Technical Service Bulletin: tsb100861

Two Designs of Metering and Timing Actuator Kits Now Available from ReCon®

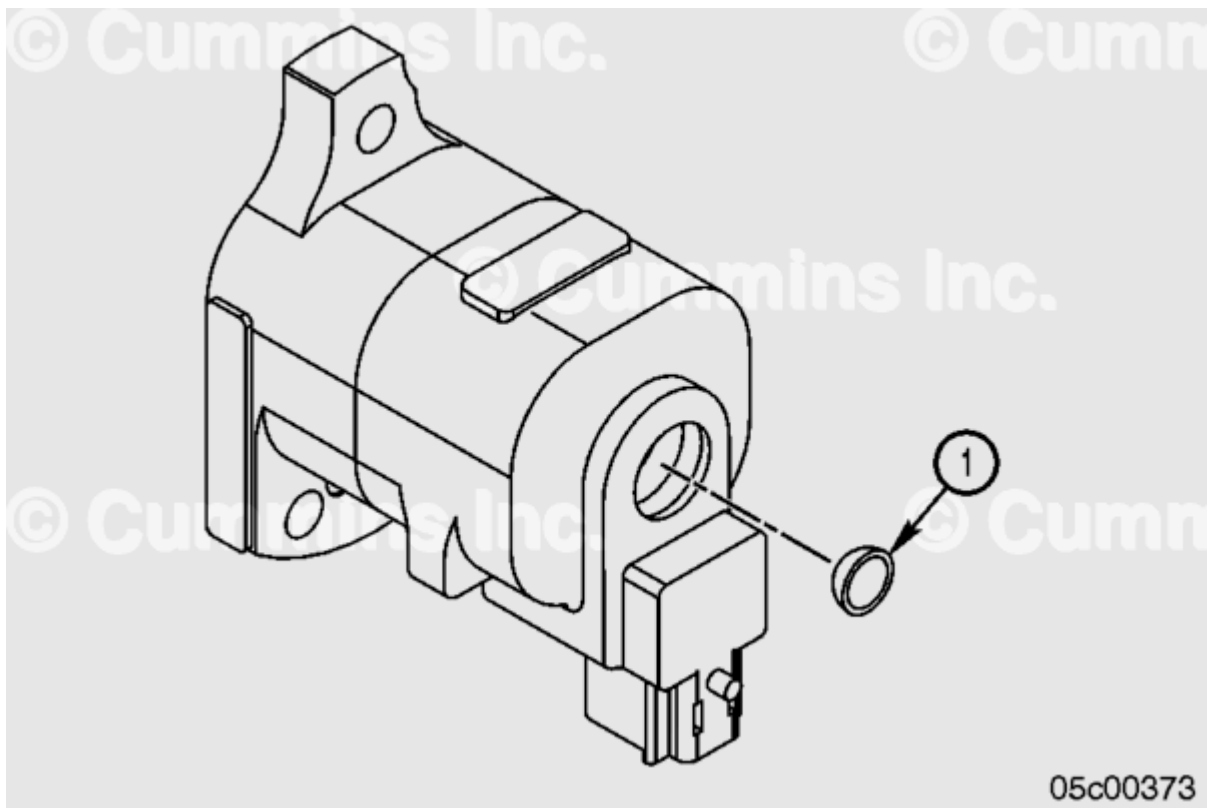
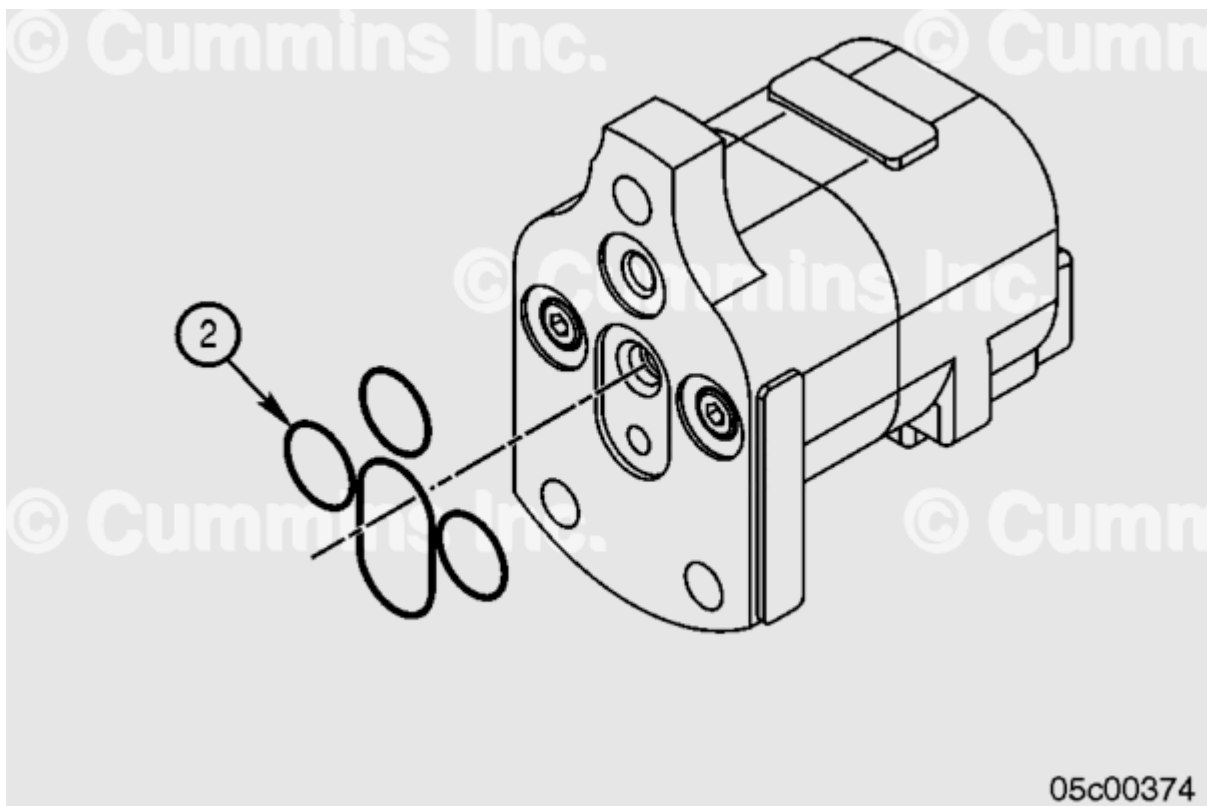
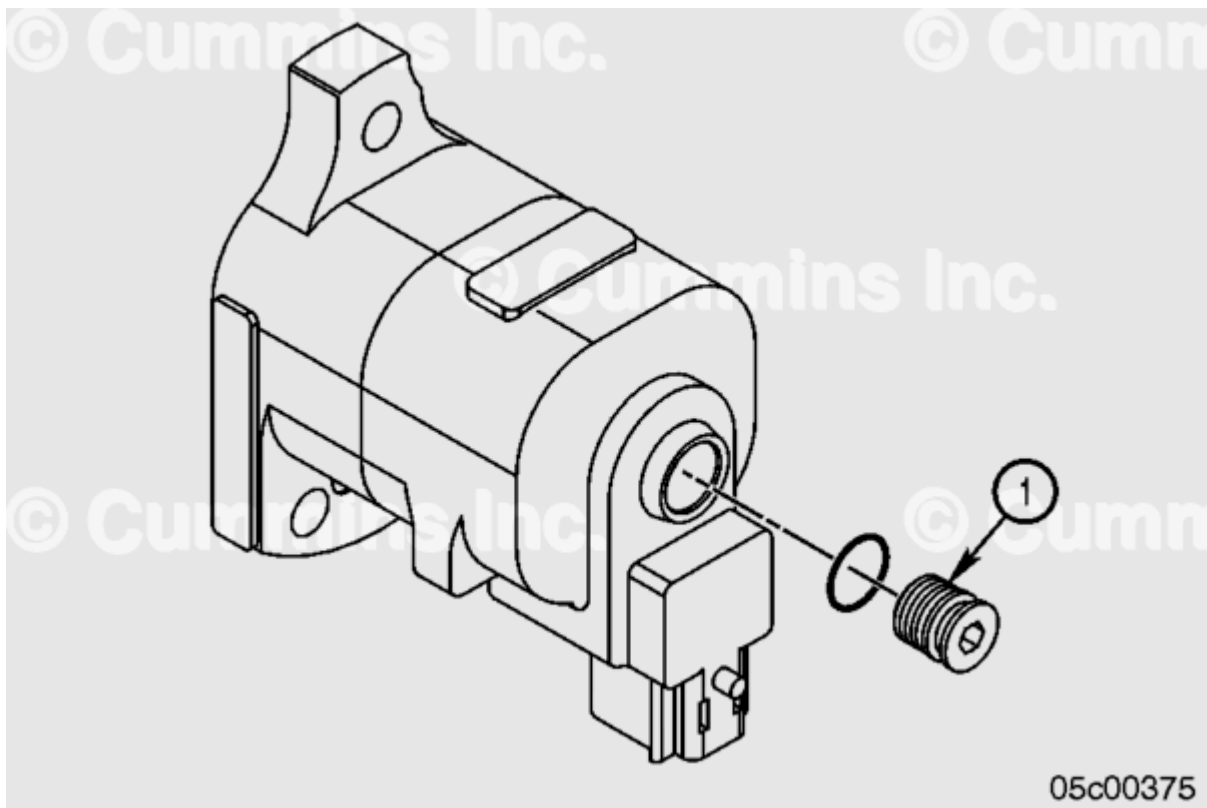
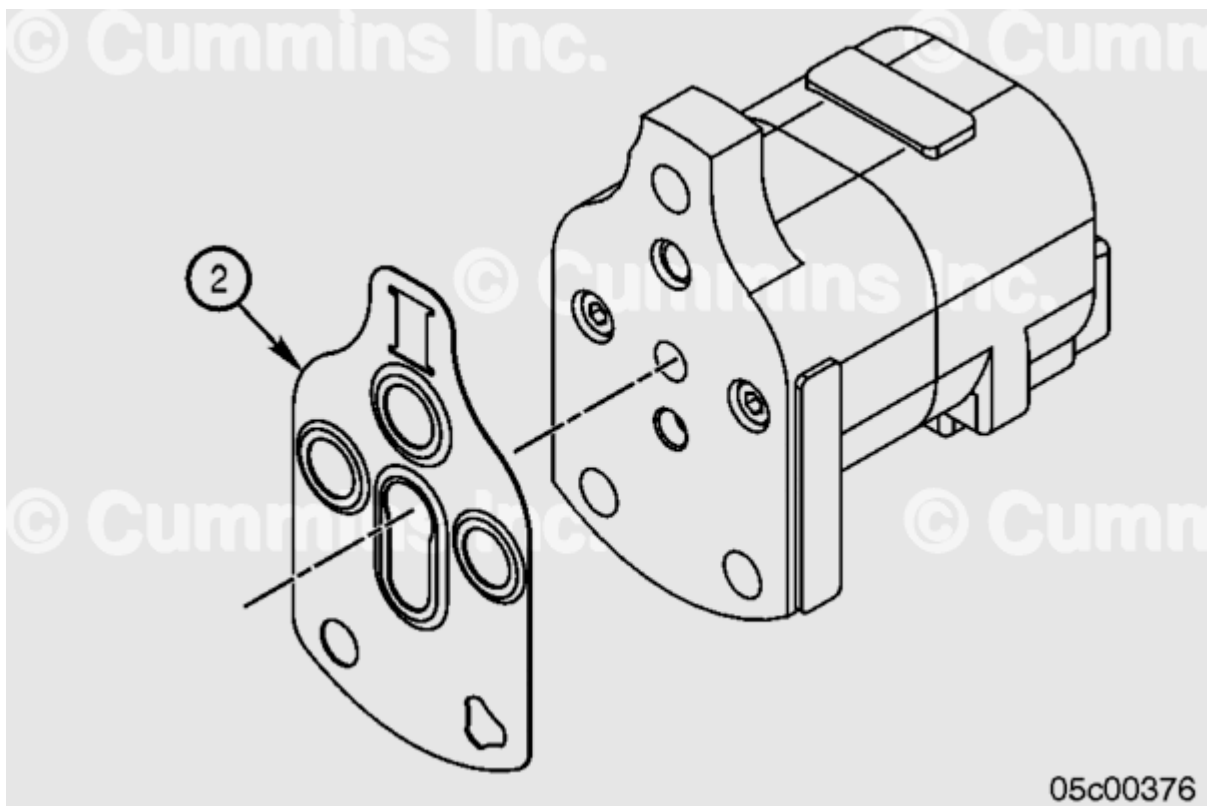
ISX metering and timing actuators have been available in a number of different designs. The two latest designs are virtually identical internally, but have either a stator housing sealed with an expansion plug and o-ring type mounting gasket or a stator housing plug with an o-ring seal and an embossed steel mounting gasket.

Until now, ReCon® **only** offered metering actuator kits (4089985RX) and timing actuator kits (4089986RX) with the stator housing plug using an o-ring seal and an embossed steel housing gasket. ReCon® is now offering both designs for sale as replacement part kits. The designs are interchangeable and either version can be installed without any problems.

Expansion plug (1) - Design 1

O-ring type mounting gasket (2) - Design 1

Plug with o-ring seal (1) - Design 2

Embossed steel mounting gasket (2) - Design 2
